CARLYLE MODEL 2950

PROJECT  
PROPOSED UNIT  
TWO STOREY DWELLING  
FOR: LORMEL HOMES  
AT: INNISFIL

**Town of Innisfil Building Dept Notes:**

**FIRST FLOOR PLAN**

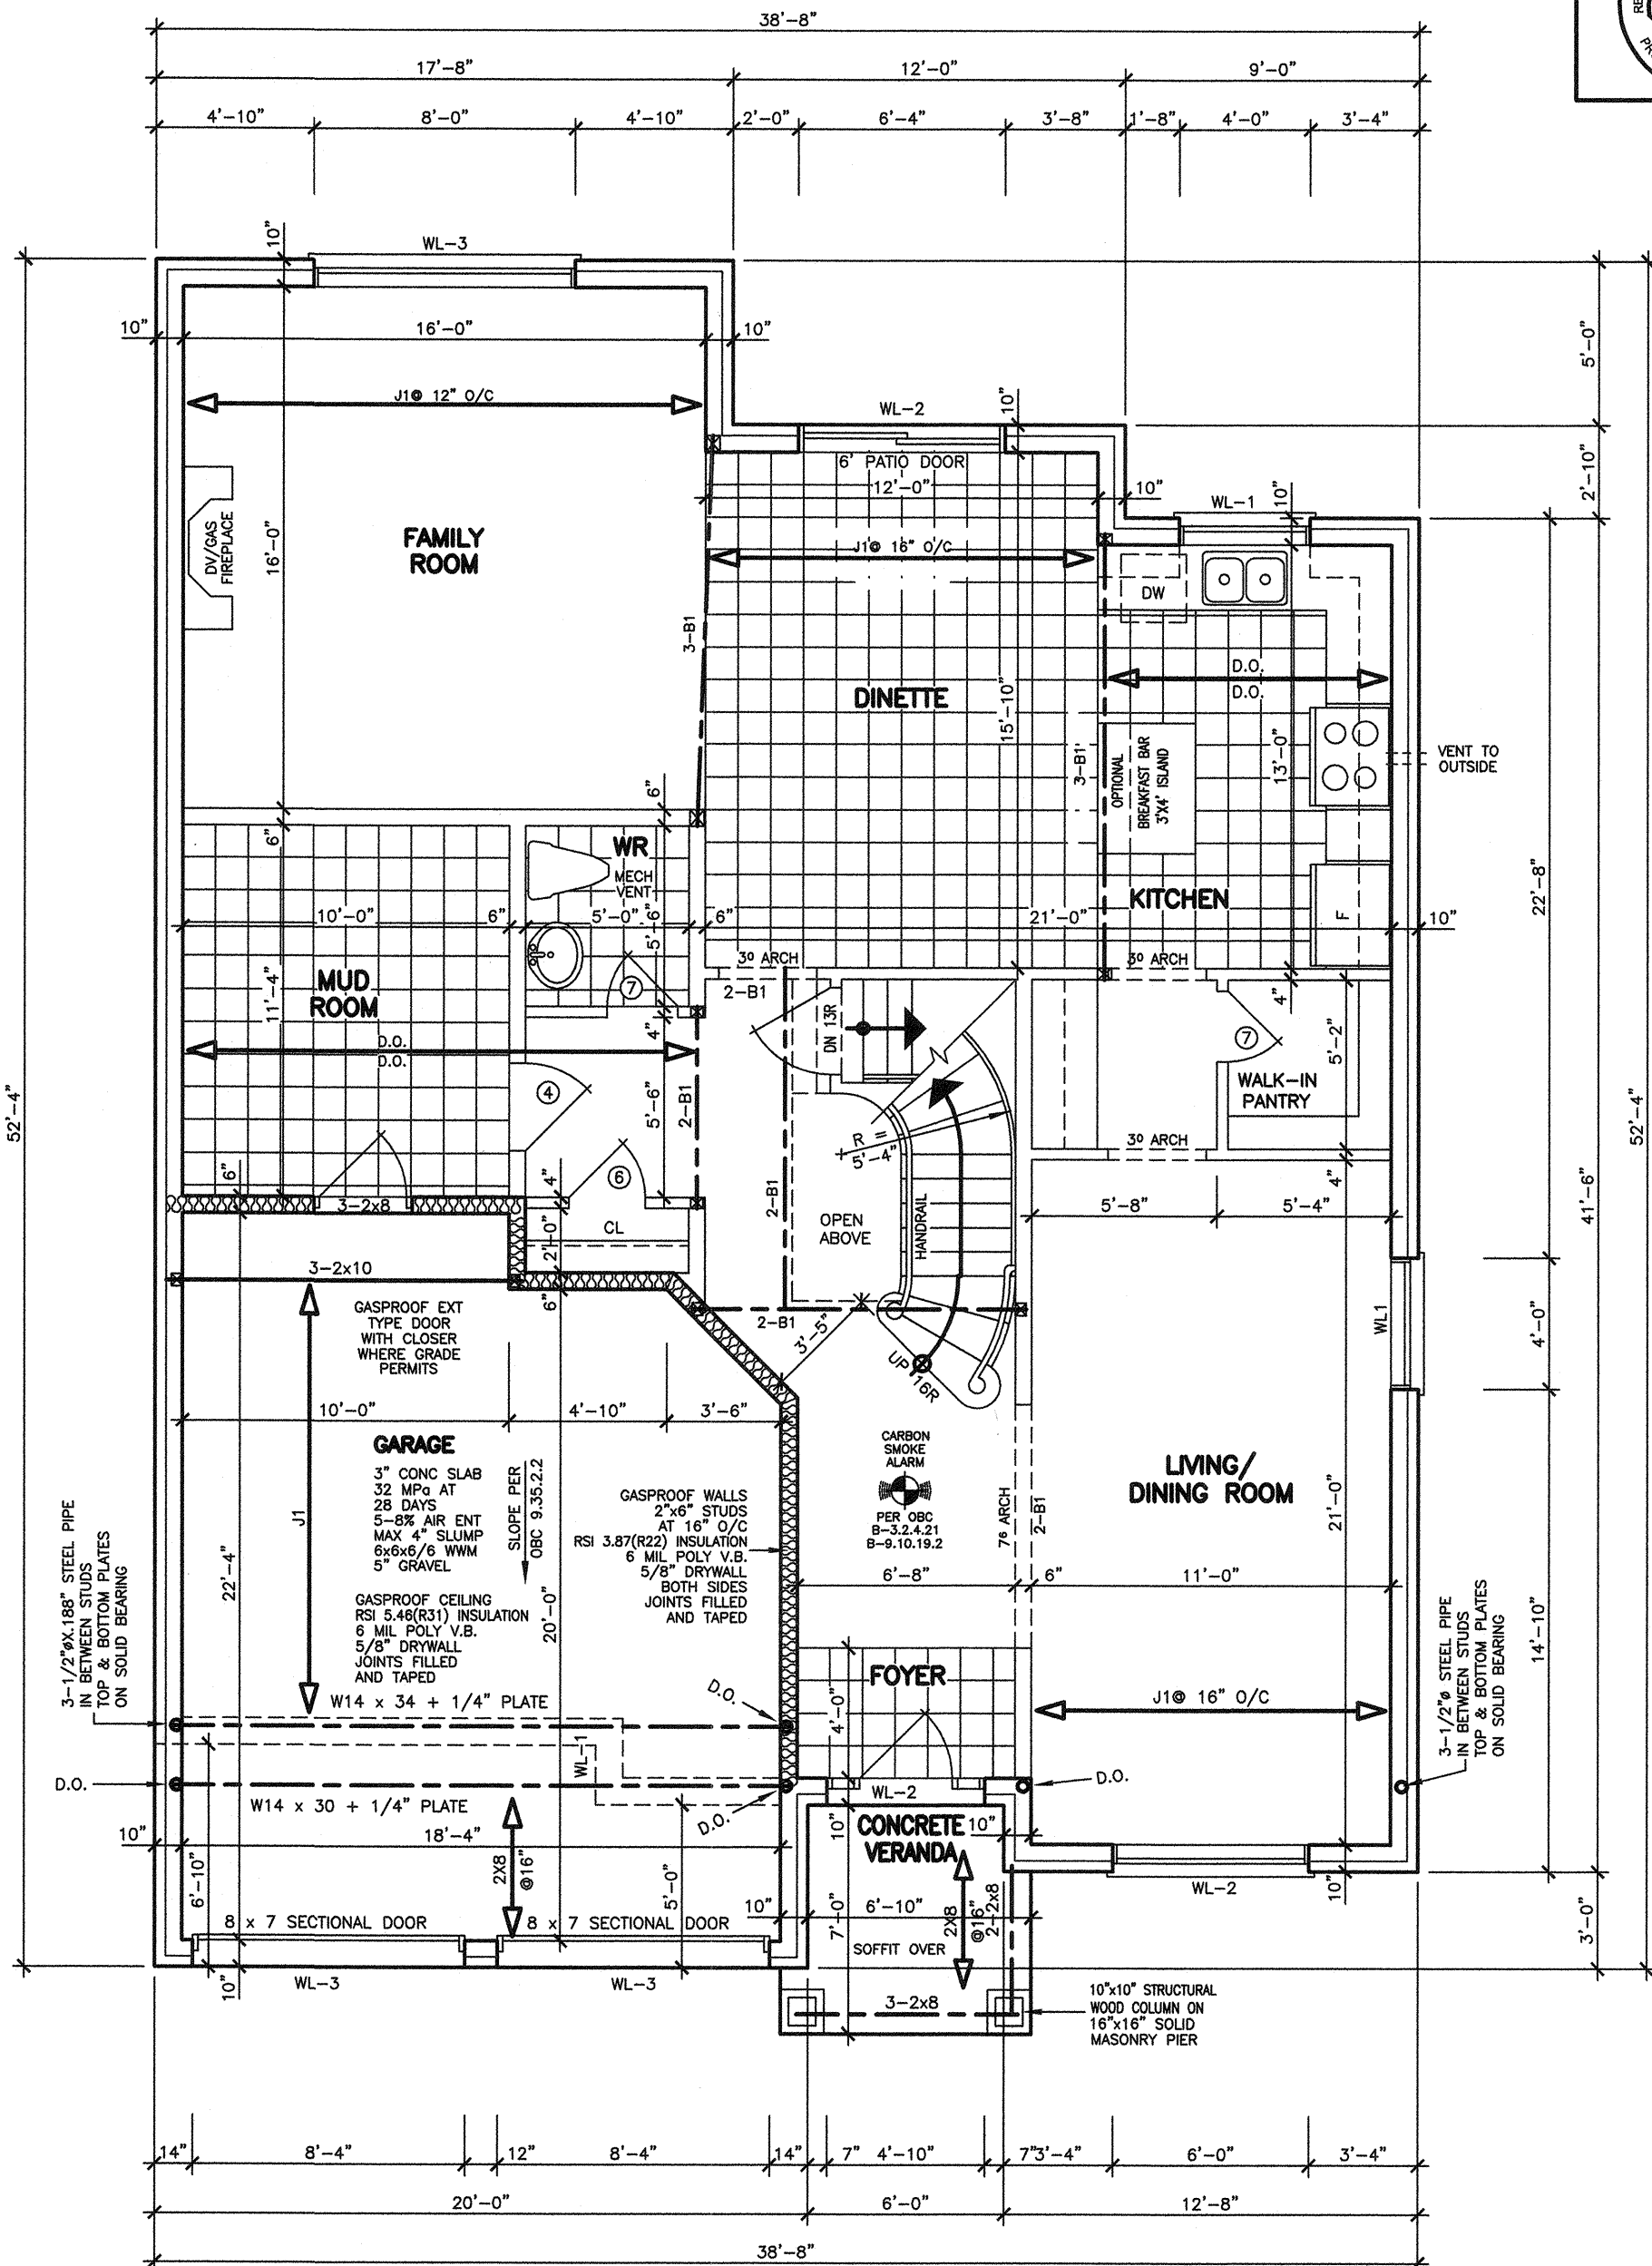
All smoke alarms and CO detectors shall comply with O.B.C. 9.10.19 and 9.33.4

Main bathroom shall be designed as per 9.5.2

All construction subject to review by Town Building Inspectors

See comments on permit

**FIRST FLOOR PLAN**

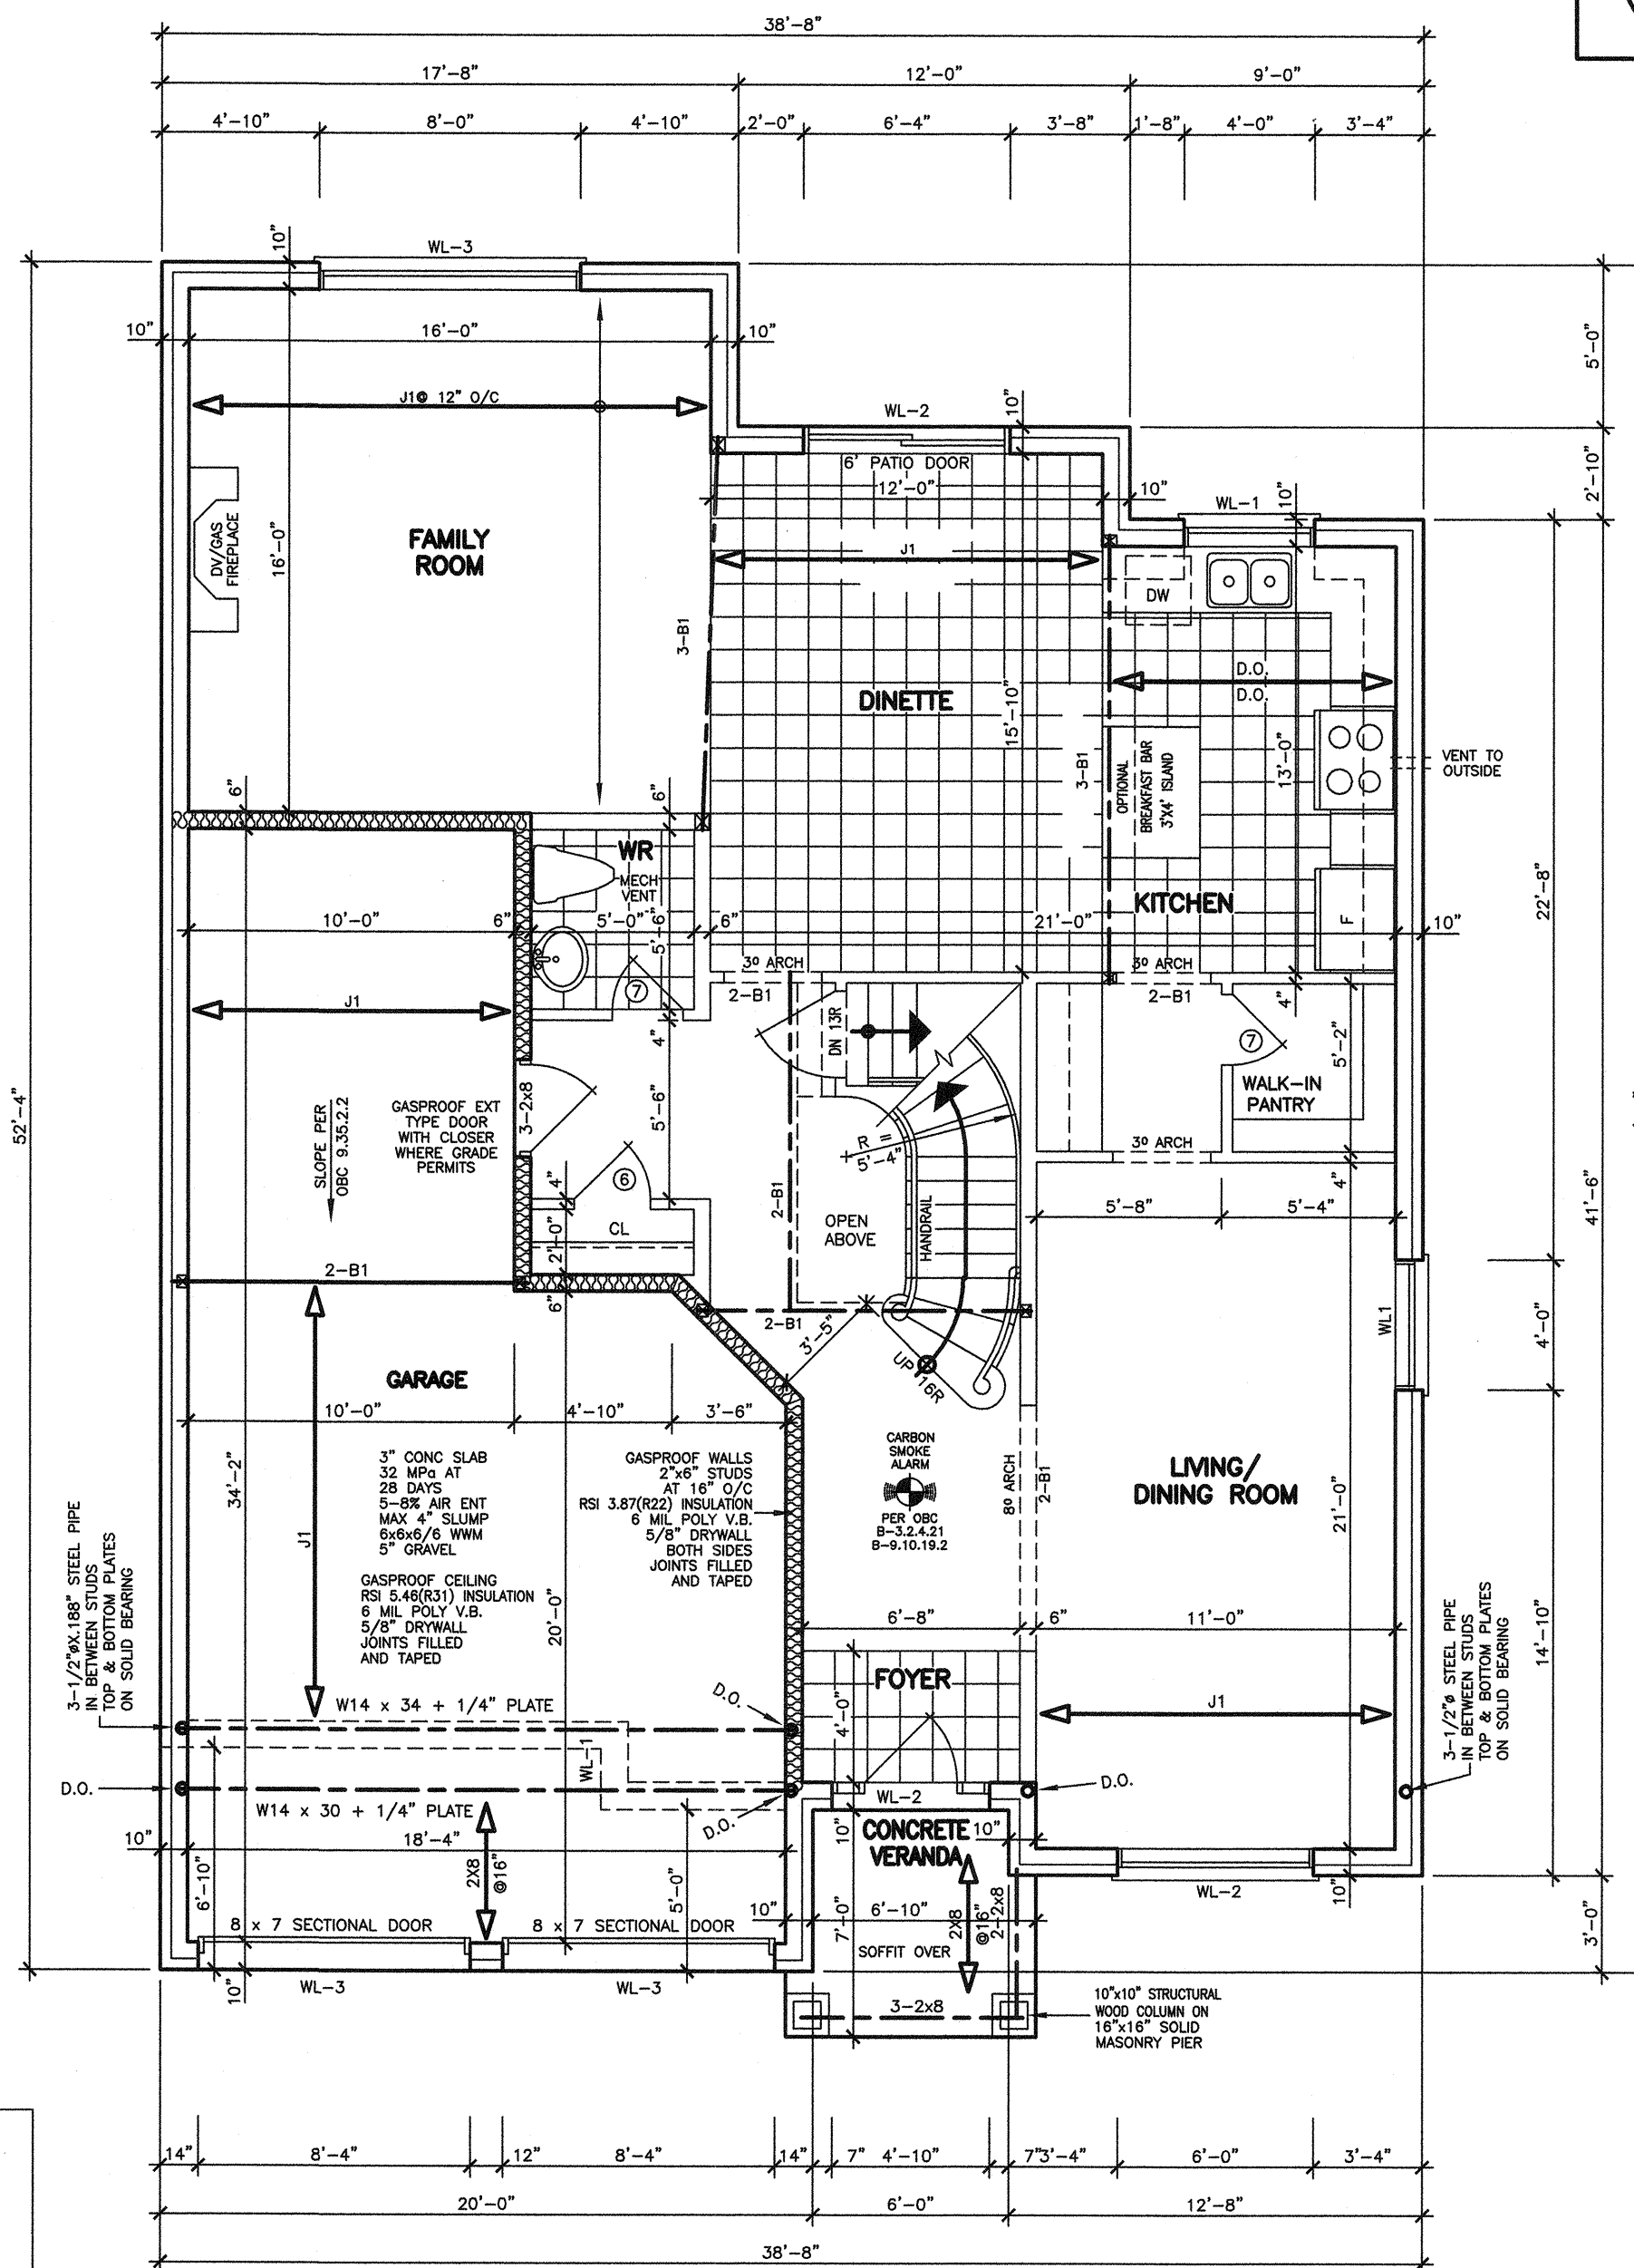
**Town of Innisfil Building Dept Notes:**  
 All smoke alarms and CO detectors shall comply with O.B.C 9.10.19 and 9.33.4  
 Main bathroom shall be designed as per 9.5.2  
 All construction subject to review by Town Building Inspectors  
 See comments on permit
